Meeting Agenda

Franklin Municipal Planning Commission

Thursday, December 15, 2016

EDDY LANE INDUSTRIAL OFFICE, SITE PLAN, REVISION 1, (PHASE 2 & 3)
FRANKLIN MUNICIPAL PLANNING COMMISSION
12/15/2016

DRAWING NAME
STORMWATER
MANAGEMENT

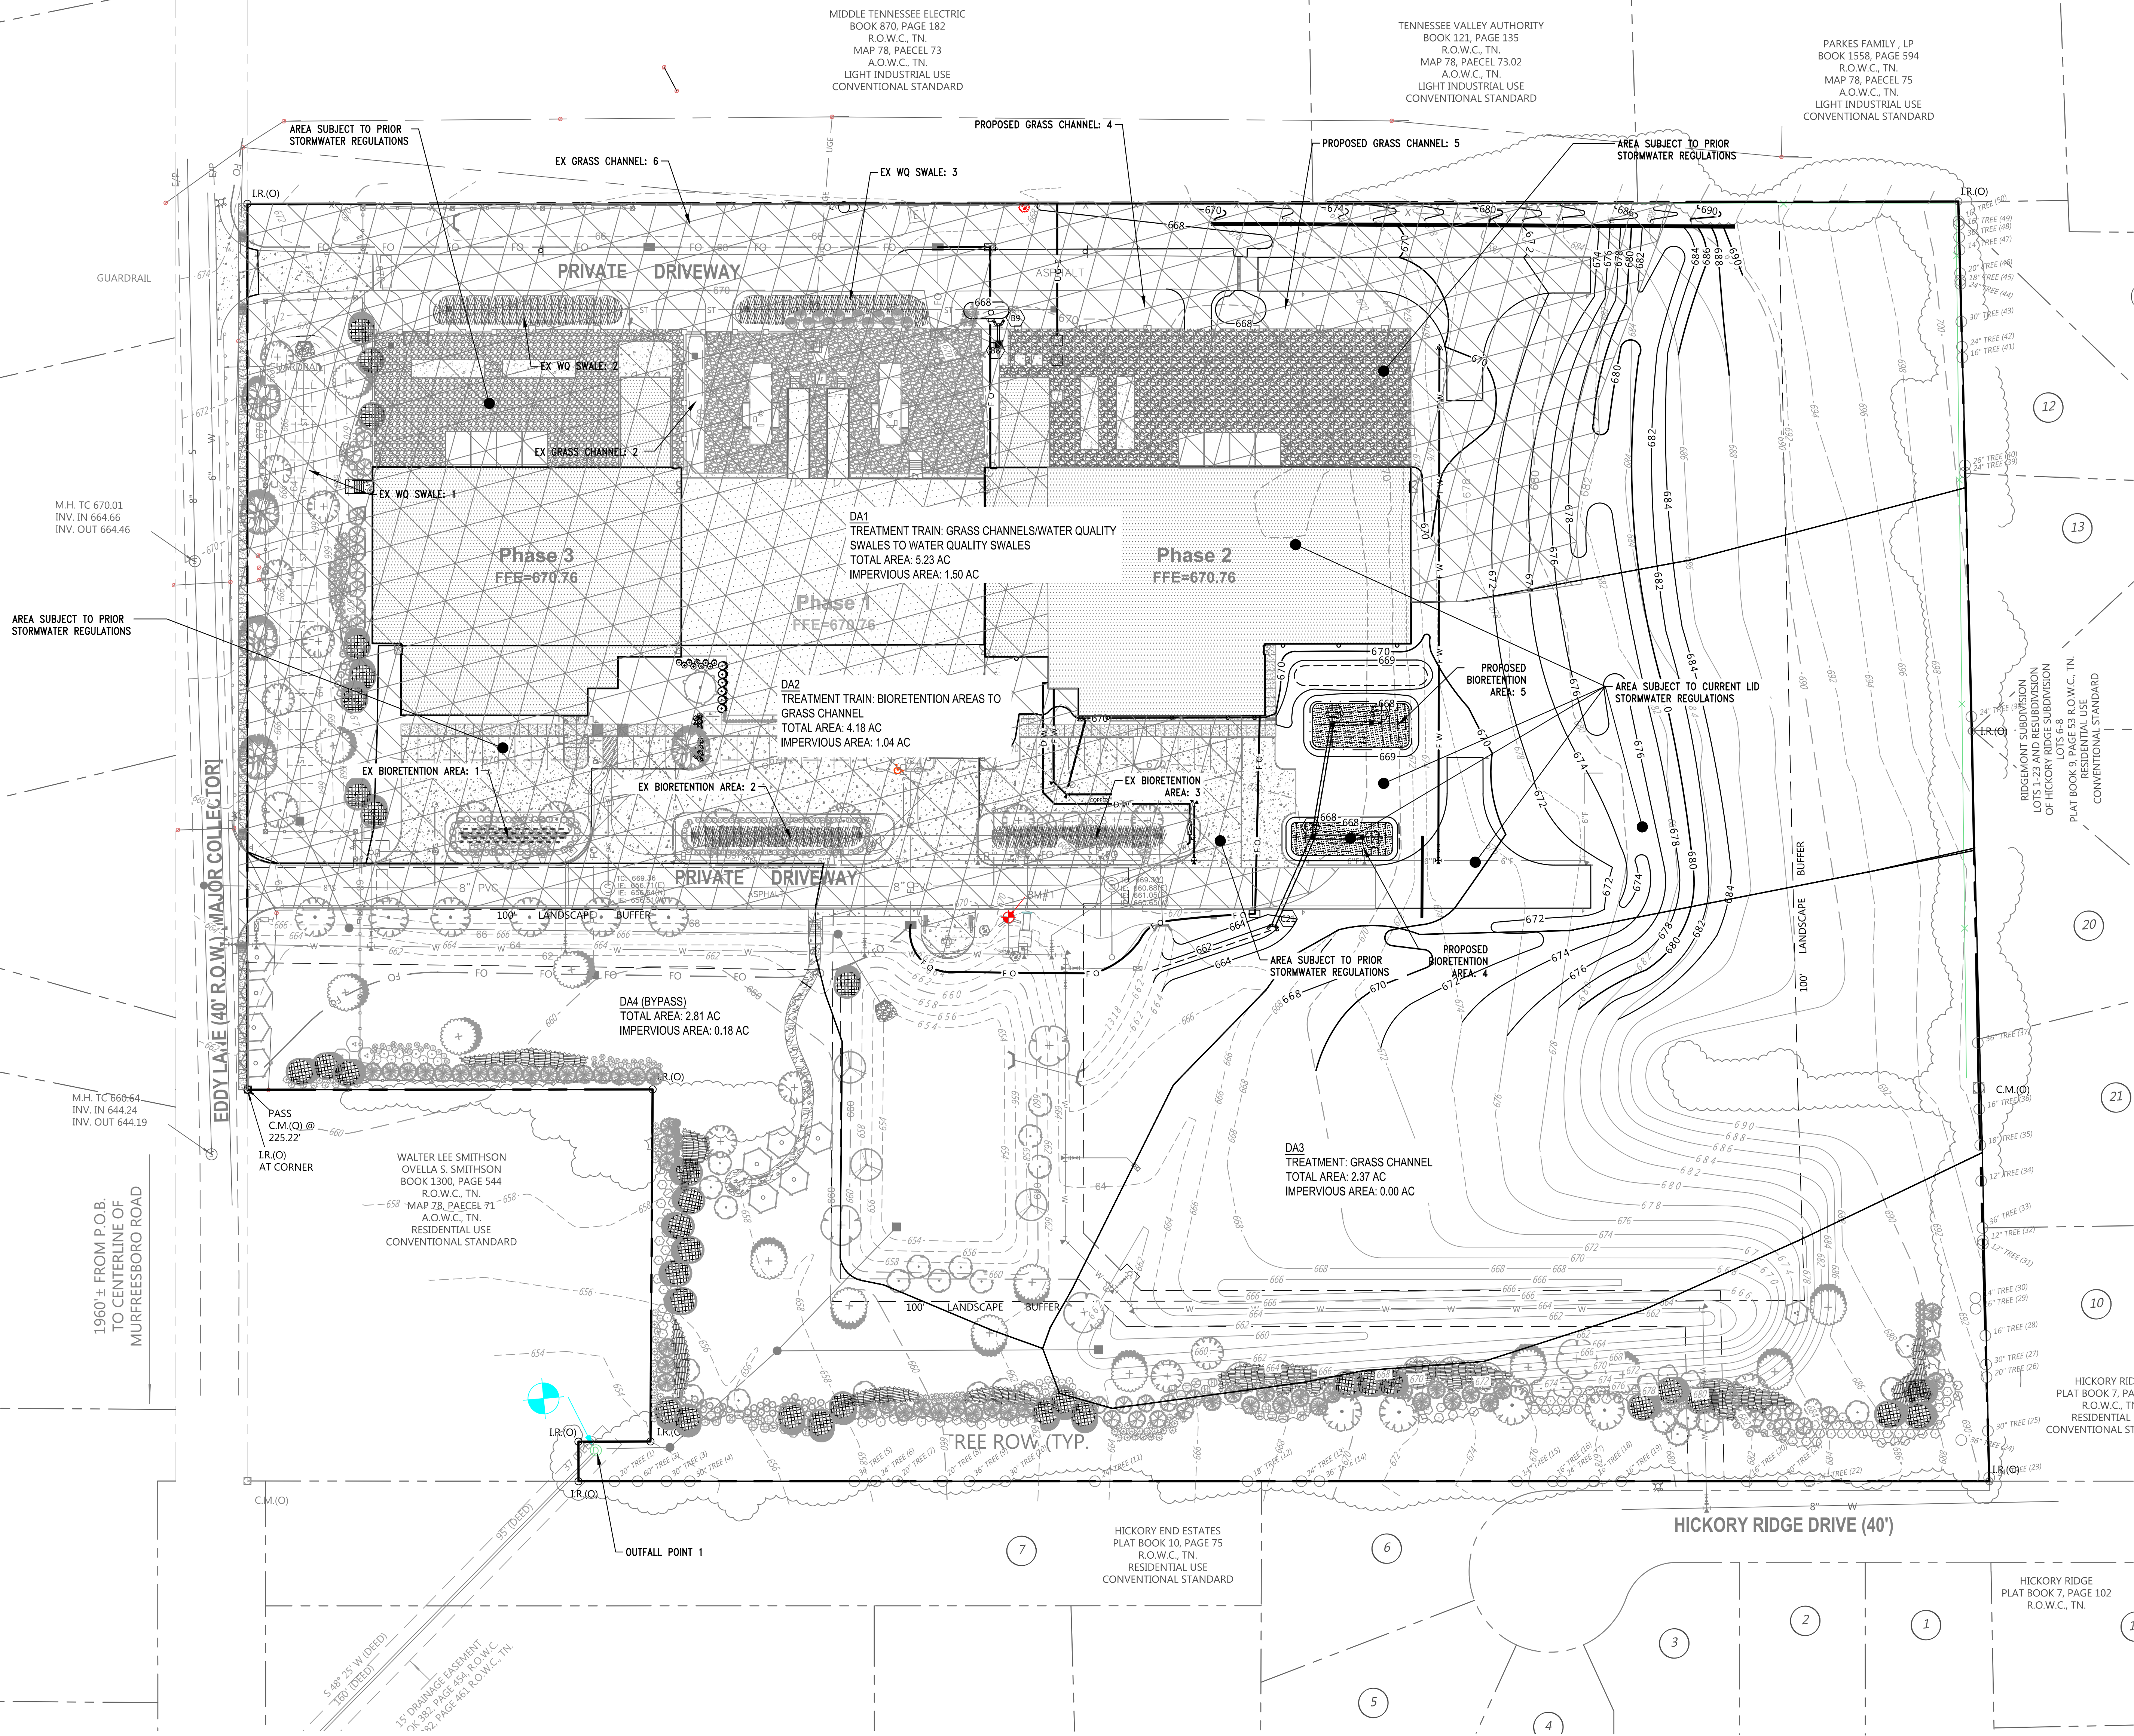
jeff.willoughby@franklintn.gov Provide pretreatment for WQ swale

Provide detail for pretreatment areas
[Edited By Jeff Willoughby]

jeff.willoughby@franklintn.gov Level II bioretention requires a 12" gravel drainage layer and 12" gravel sump layer as per Level II specs. Please revise.

Soil specifications in WQ swale shall match those in bioretention area. Please revise.

awolthers@leainc.com The water quality swales have been removed from the plans and details. Drainage on the north side of the building will drain to grass swales and then to the existing water c infrastructure installed in phase 1. This area is grandfathered into the original design. The area north of the building will still receive some pretreatment since that area is covered with washed #57 stone.

awolthers@leainc.com The bioretention details have been revised as requested. The water quality swales and details have been eliminated from the plans.

DRAWING NAME
UTILITY DETAILS

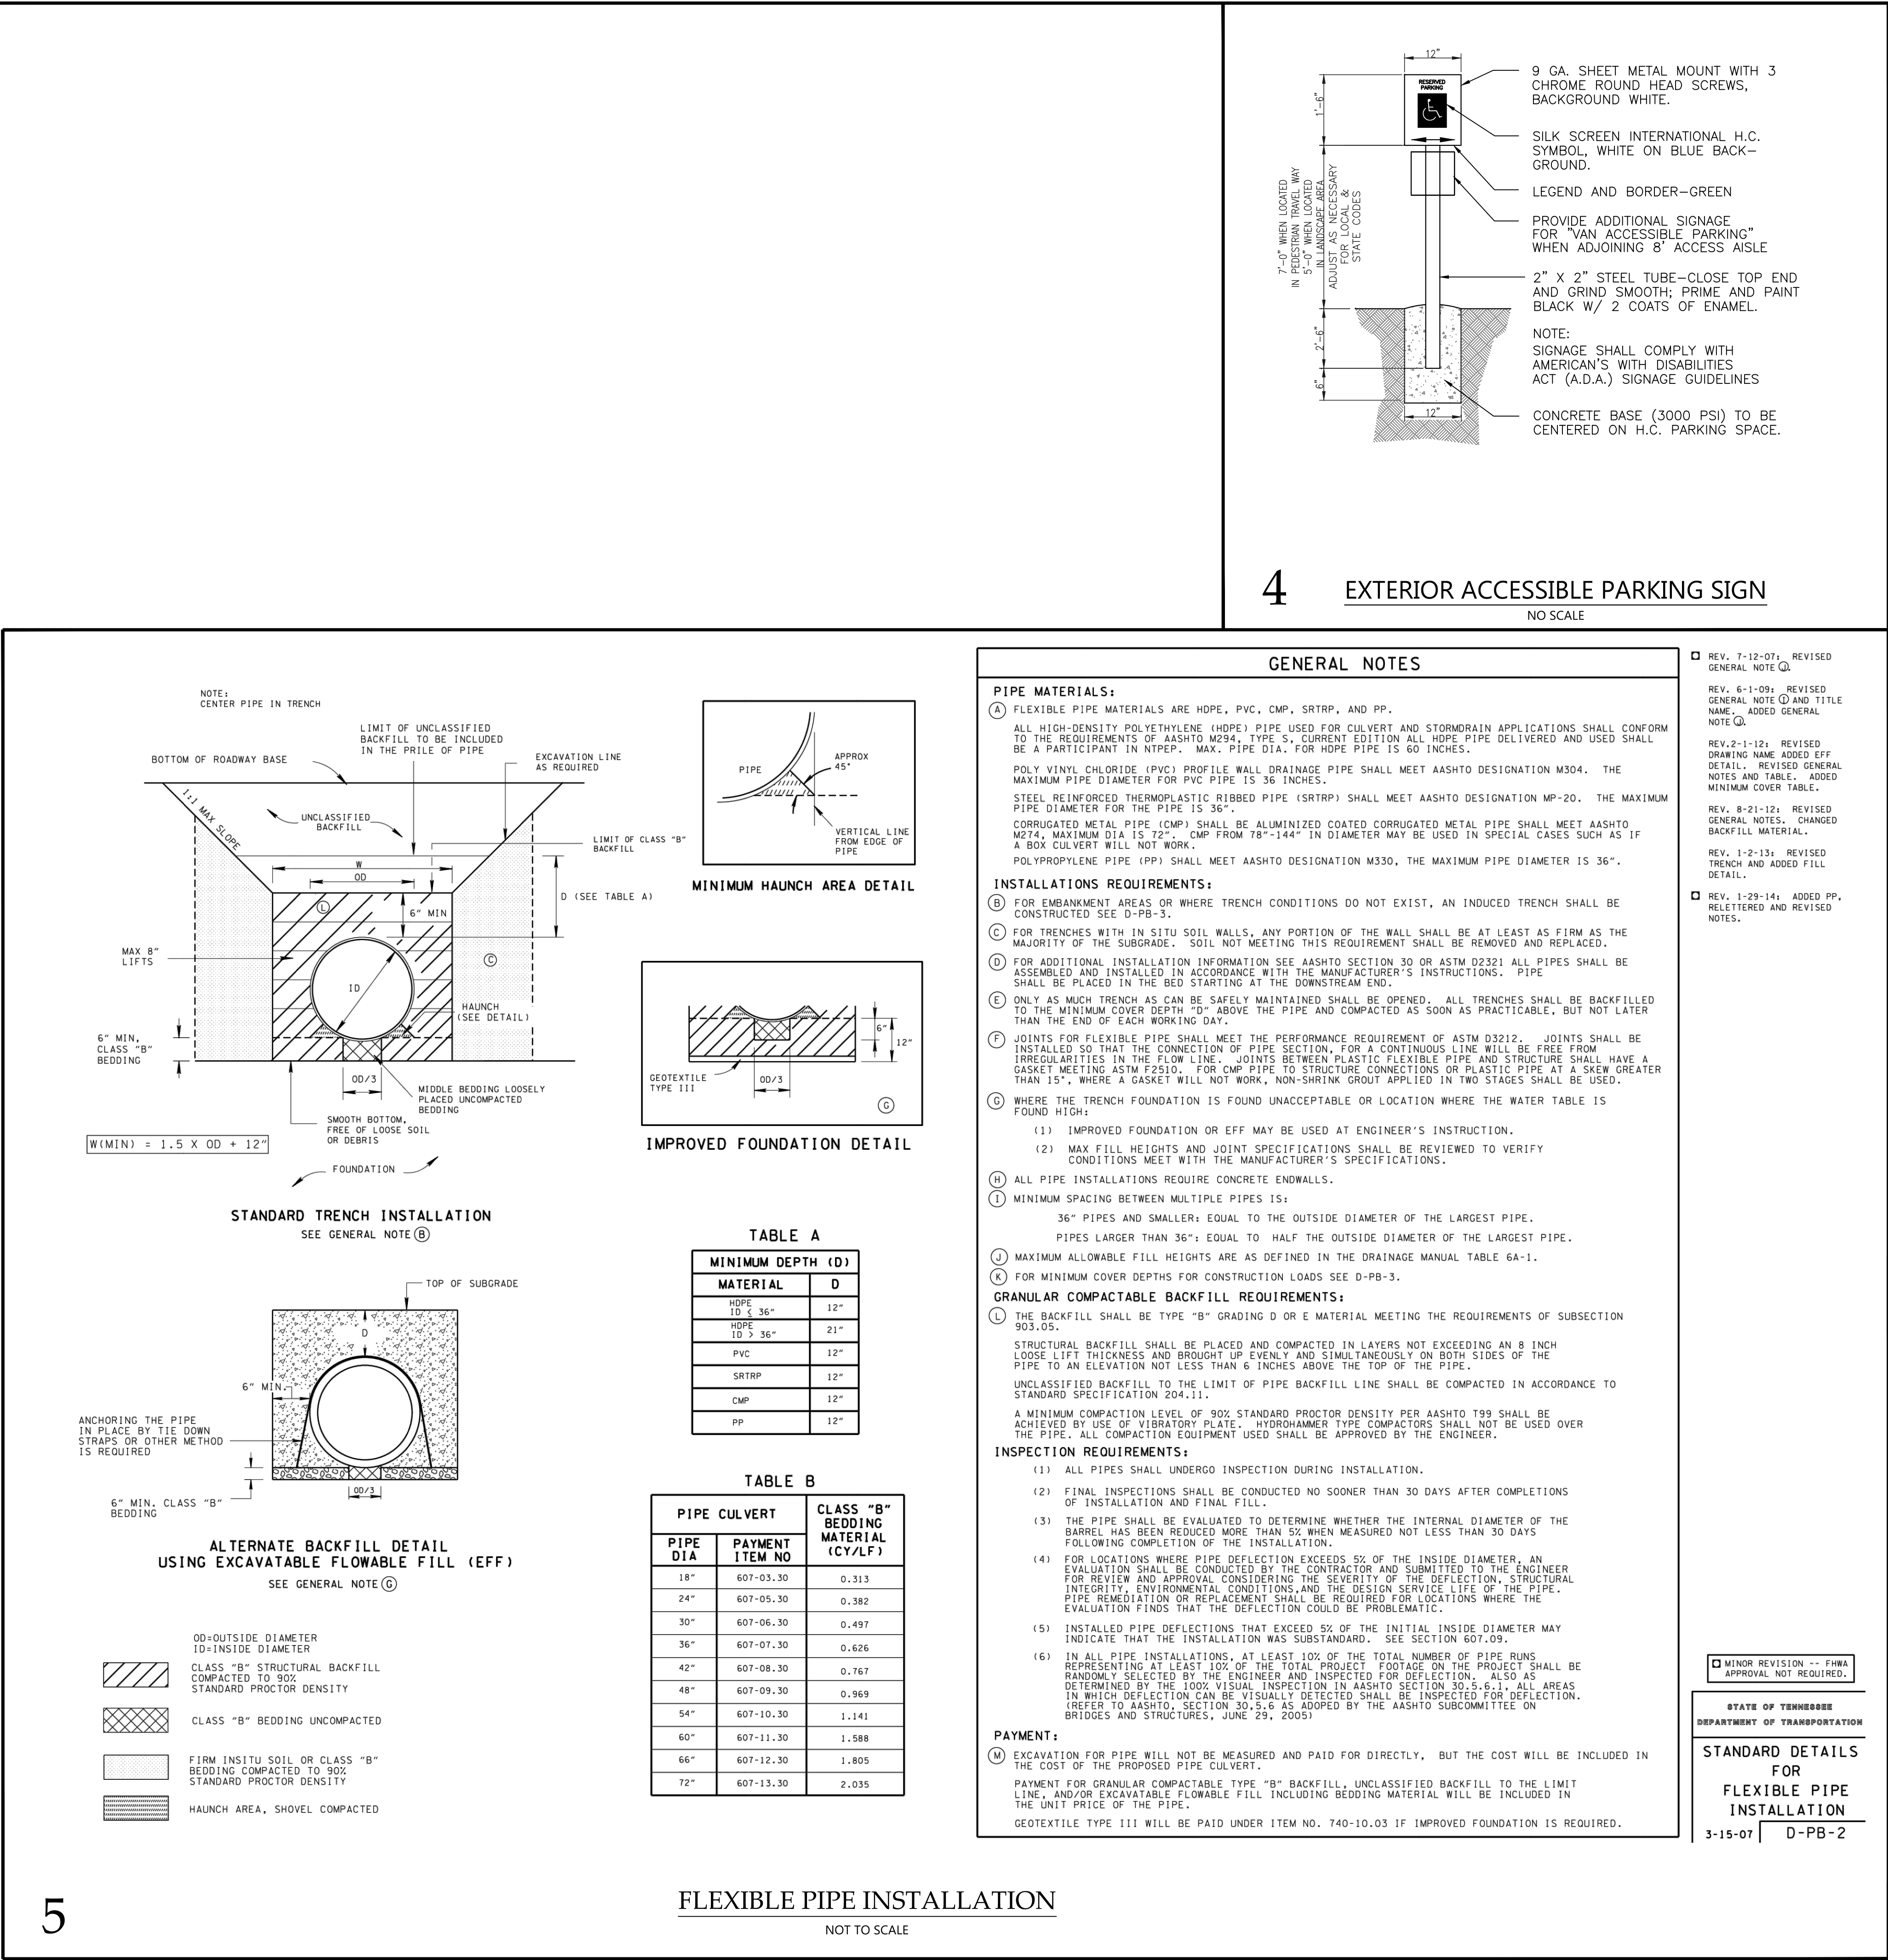
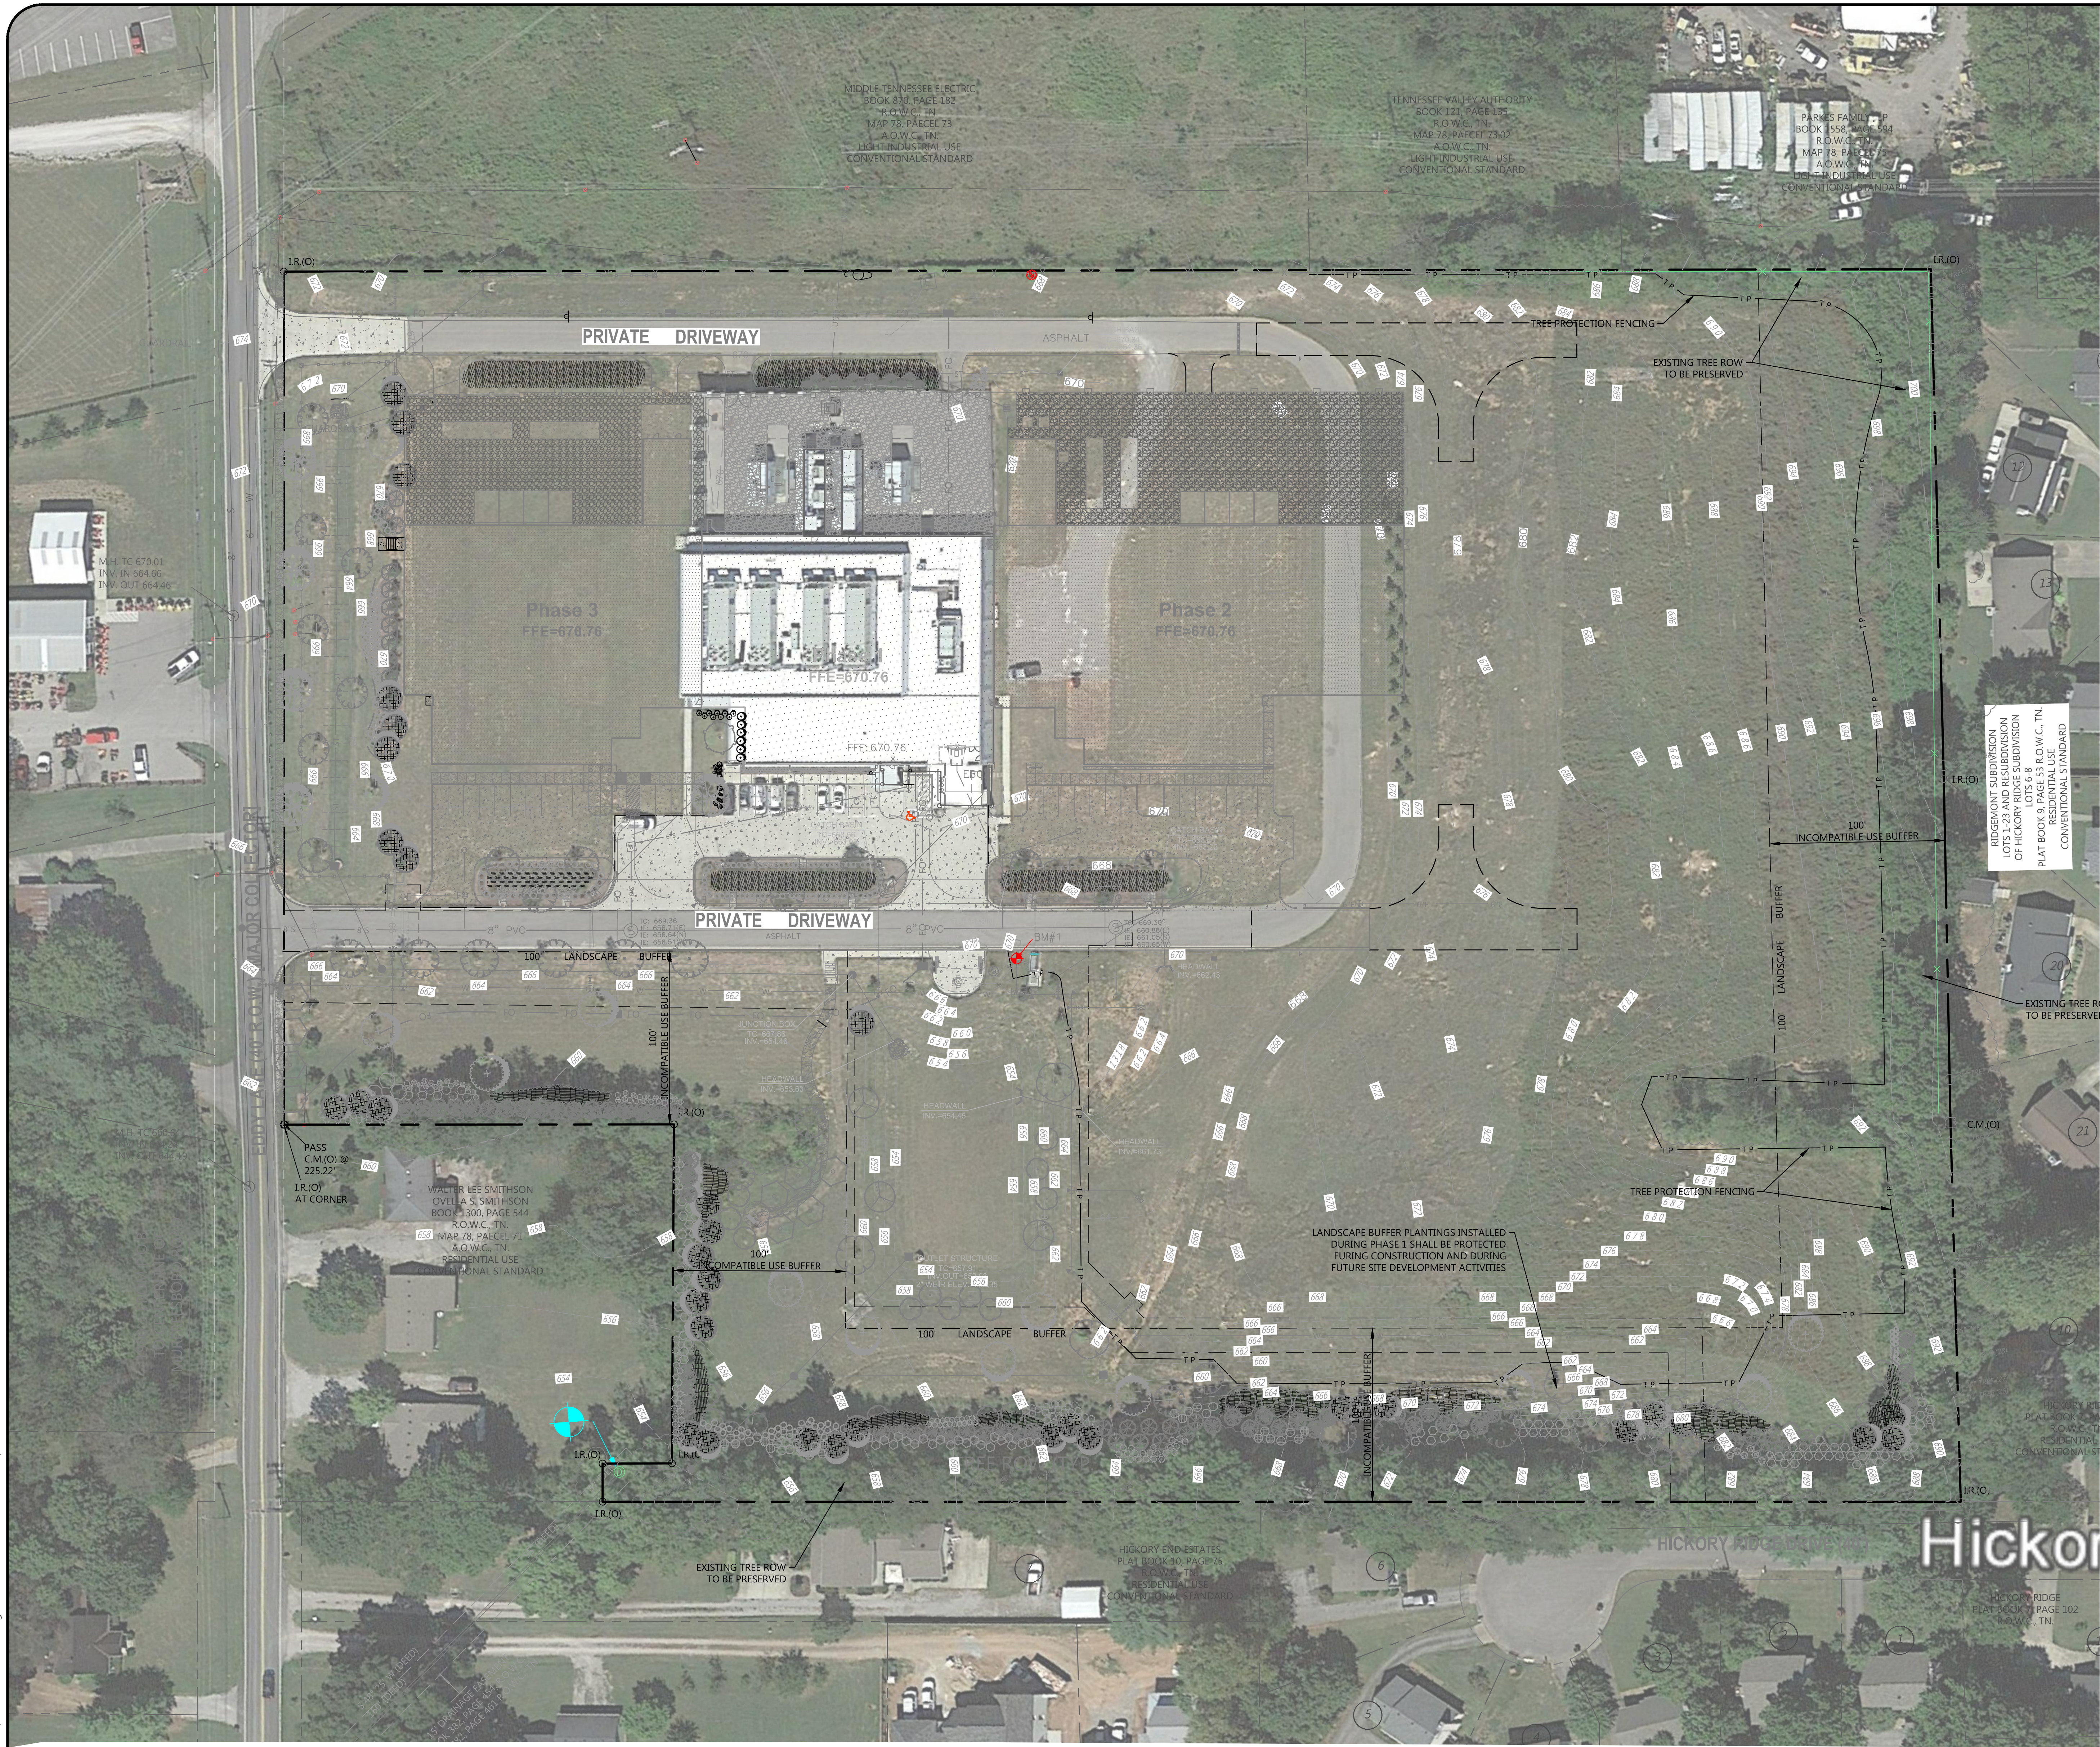
8. Stormwater detail

casey.chrisman@franklintn.gov Add flexible pipe detail.
